SIB 34 04 23

RECALL 24V-104: INTEGRATED BRAKE SYSTEM (IB)

This Service Information Bulletin (Revision 6) replaces SI B34 04 23 **dated March 2024**.

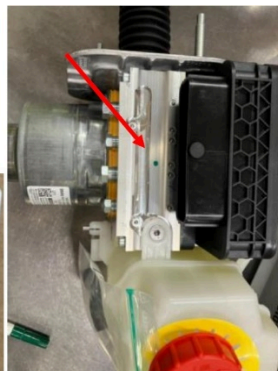
The following process only applies to service parts from production “Made in Germany DE” as shown in the red box on the parts label.

Determine the country of manufacturer of the component. If made in the USA proceed with the installation.

Note: Label photo is example showing manufacturing location and may not reflect the part number you received.

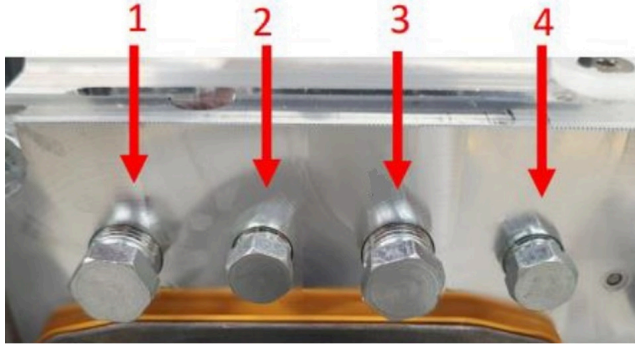
Inspection procedure applies to the service parts **without** a green dot on the label and IB.

When the part has a “green dot” on the label and on the part itself, as indicated by the red arrows shown in the pictures; **the part has already been checked and is OK for use.**

1. Place the IB on a solid surface.
2. Set a torque wrench to the first mounted blind plug and open it with the defined torque.

Defined torque

- 2a) M10 (plug #2 and #4) max 15 Nm.
- 2b) M12 (plug #1 and #3) max 12 Nm.

3. Using the defined torque wrench setting, remove the remaining plugs (2,3,4)

4. The part is OK if the plugs open with a lower torque than the defined values.

5. Inspect the plug bores for thread damage and/or metallic particles.
